Response to Agency Preliminary Comments on Labadie Energy Center §316(a) Draft Demonstration Study Report

MDNR/MDC Comments

Figure 1. Seasonal fraction of the fish community comprised of heat intolerant species as numbers (left) and biomass (right) in the vicinity of the LEC in 2017-2018.

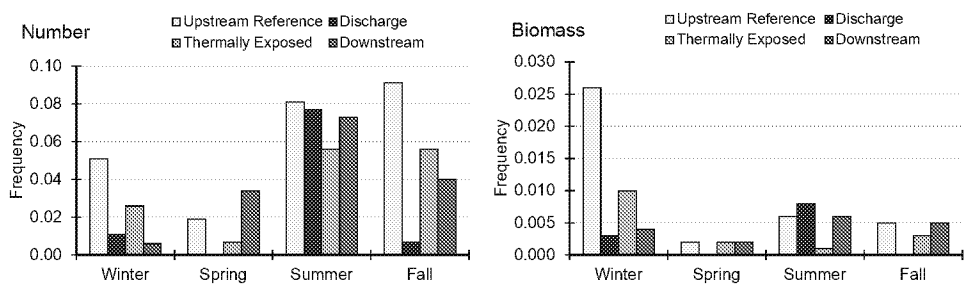
c. In addition to this, please graph these by season as Section 6.3.3 indicates certain intolerant species will be completely absent if the river exceeds certain temperatures. Seasonal density graphs were completed for the macroinvertebrate community in Figure 5-24.

c. Graphs in Section 5 were selected to illustrate patterns in the data, without overwhelming the reader with more graphics than can be assimilated. The seasonal aspect of the prevalence of heat tolerant and intolerant species was incorporated into the analysis. The data for tolerant and intolerant species, segregated by gear and season, are provided in Appendix B Tables B-14 through B-17. The standardized differences between Upstream and either Thermally Exposed or Downstream zones, based on each of these combinations for fraction intolerant species are provided in Appendix B Tables B-18 through B-21. All of the standardized differences for each combination of gear x season, for both numerical abundance and biomass (without preference) were included in the overall weight of evidence, along with differences based on other metrics, in Figure 5-22.

To satisfy the request, figures similar to Figure 1 are provided in the Supplement (Section 3) to demonstrate the seasonal component of heat-intolerant species as it relates to numerical abundance and biomass.

Figure 2. Maximum temperature at the edge of the 25% Mixing Zone vs. TDP

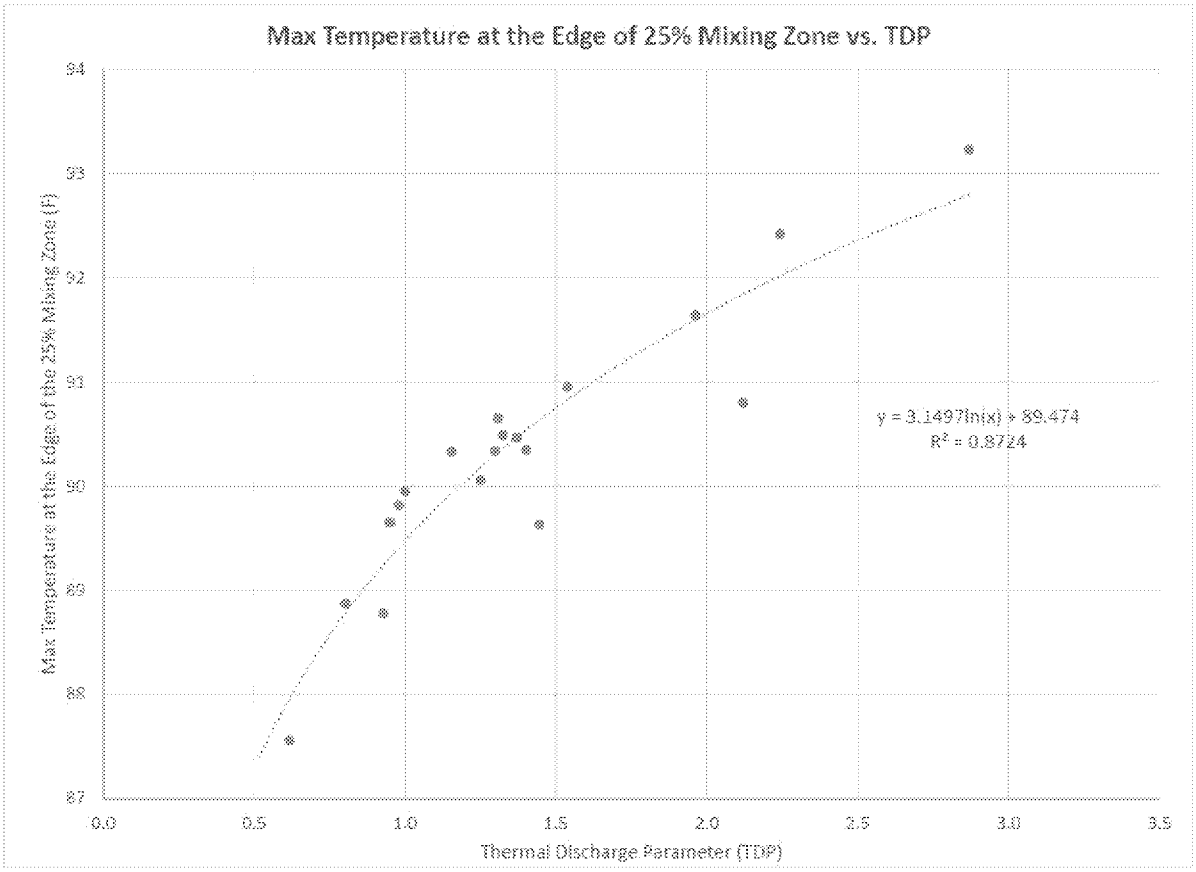
7. The Ameren variance request appears to be based on the logic of the Mississippi River criteria and this seems appropriate. The questions/comments below are based on that approach. While variable with river temperature, what is the more elevated temperature (>5°F) at the edge of the 25% mixing zone when the RMZ is expanded to 40% of the river? Does this equate to an additional 3°F increase above 90°F? Is the 40% value based on a calculated zone of passage or a maximum temperature at the higher RMZ? Ameren's variance request should define the increase in temperature above 90°F when the larger RMZ is allowed.

In response to this comment, we analyzed the model output from a subset of the previously conducted simulations that were run to develop the effluent limitation equations in Tables A-1 and A-2 of the NPDES permit. For each simulation, we determined the location along the river where the maximum temperature occurs after mixing with only 25% of the river flow. At all other locations, the temperature would of course be less than the maximum. The simulations analyzed represent a range of river and discharge temperatures and flows.

The results for the maximum temperature at the edge of the 25% mixing zone for each simulation are provided in the attached Figure. As expected, the Figure demonstrates that the maximum temperature is a function of the TDP. (Recall that the TDP is a composite measure of the combined effect of river and discharge flows and temperatures.) As can be seen, the maximum temperature at the edge of the 25% mixing zone will exceed 90°F at TDP values above 1, again as expected and as we have previously demonstrated. Nonetheless, the Figure further demonstrates that maximum temperature at the edge of the 25% mixing zone will always be below 94°F even for a simulation with TDP as high as 2.87. Analysis of the historical database (January 2002 – December 2018) indicates that TDP never would have exceeded 2.65. So, even when the variance may be invoked allowing temperature in the river to exceed 90°F in up to 40% of the river, the temperature will still be below 94°F in 75% of the river (i.e., be above 94°F in only 25% or less of the river), and will be below 90°F in 60% of the river (i.e., above 90°F in only 40% or less of the river). Furthermore, these maximum percentages will occur for only a small segment of the river and will be less at all other locations in the river.

For most instances during which the variance may be invoked the maximum temperature at the edge of the 25% mixing zone will only be one or two degrees above 90°F. For example, as shown in Figure 2, for a TDP value of 2.3, the maximum temperature at the edge of the 25% mixing zone will still only be about 92°F. And, TDP values at or above 2.3 would be extremely rare. The historical record shows that such has occurred on only 4 days out of 6018 days (less than 0.1% of the time). So, on days when the variance will be invoked, the maximum river temperature at the edge of the 25% mixing zone will typically be around one and almost always less than two degrees above 90°F, but never above 94°F.
